MACHINE SERVICE BULLETIN NO. 127

SUBJECT: MA Model Power Unit

DATE: February 19, 1932

POWER UNIT FOR M.A. MODEL

NO. 127
30-794 X2

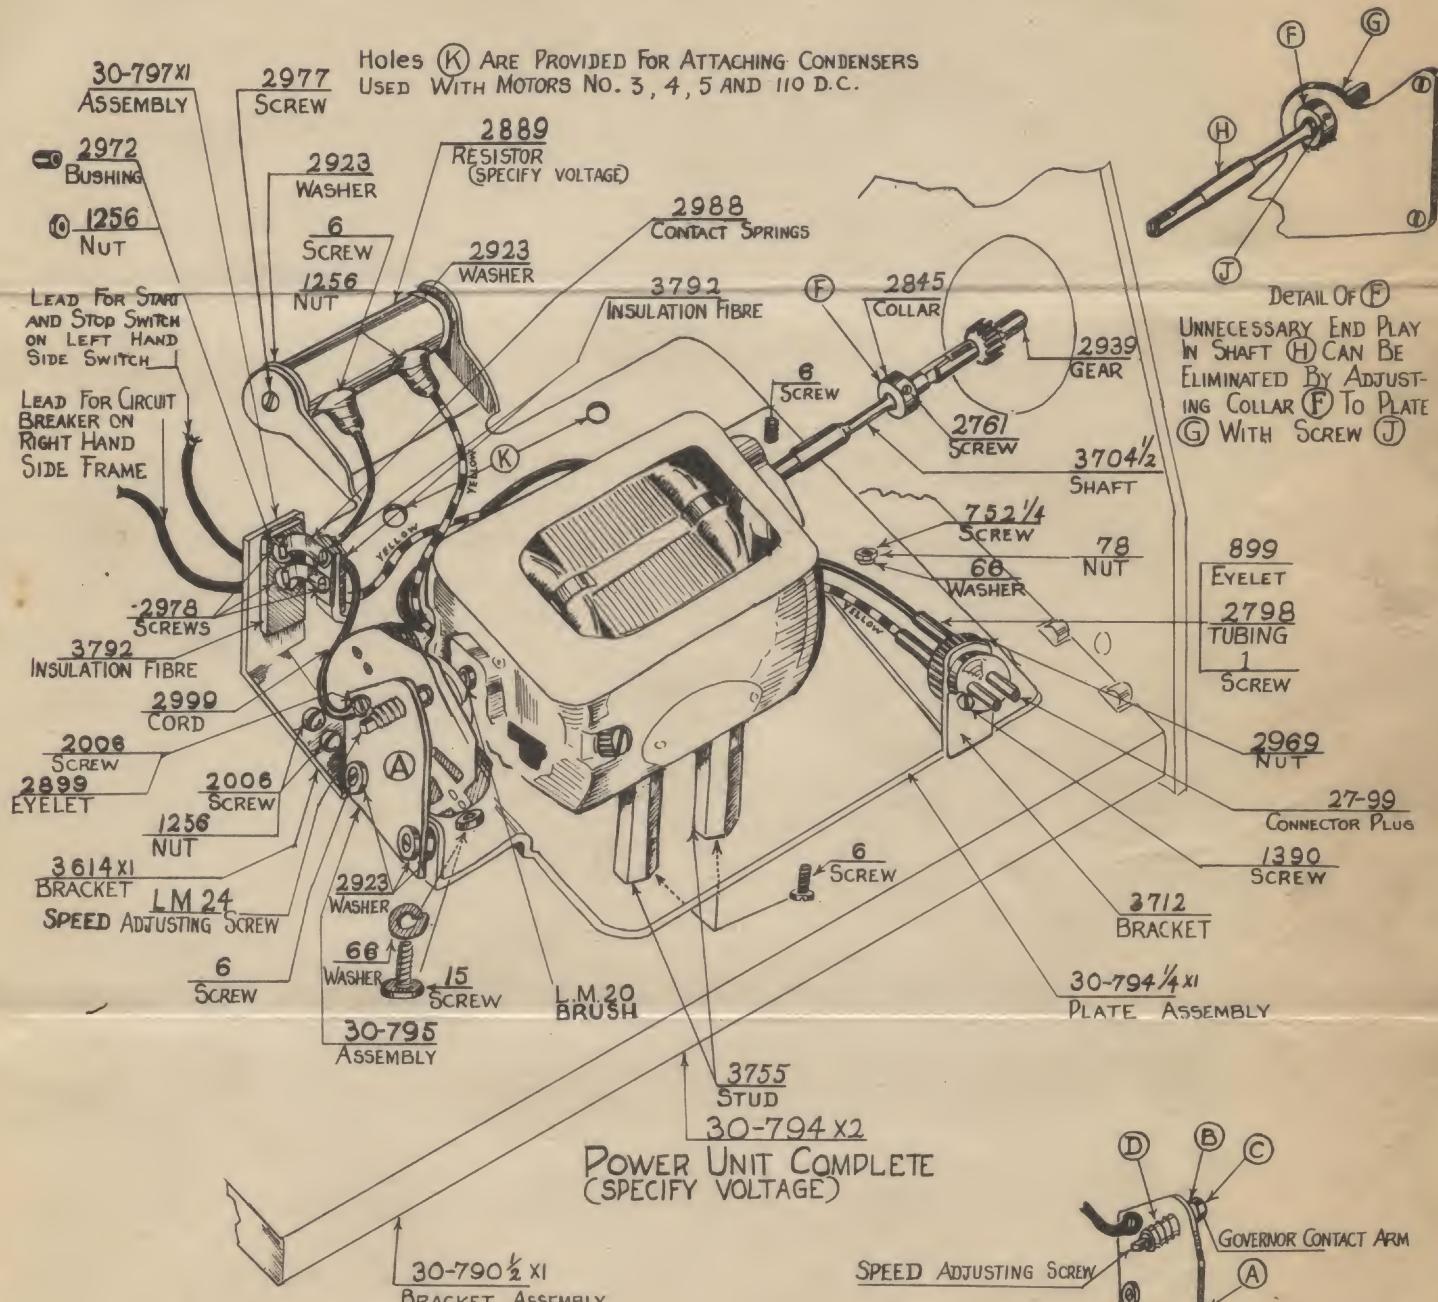
Adjust collar 2845 (F) with Plate (G).

Adjust contact bracket assembly 30-795 with governor contact arm (C).

ALIGNMENT OF CONTACT SCREW (D)
WITH GOVERNOR CONTACT (C) AT (B) IS
OBTAINED BY ADJUSTING BRACKET (A)
WITH SCREWS (E)
